UNITED STATES PATENT AND TRADEMARK OFFICE

Office Action Summary	Application No.	Applicant(s)	
	10/500,077	PROULX ET AL.	
	Examiner LAURA A. BOUCHELLE	Art Unit 3763

DETAILED ACTION

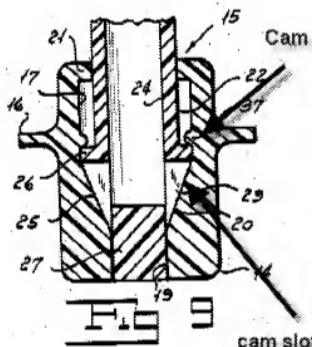
8. Applicant argues that Mackal fails to teach a cam and a slot. Figure 9 of Mackal is annotated below. The cam slot is formed between the projection 37 and the distal end of the body, and the cam extends therein.
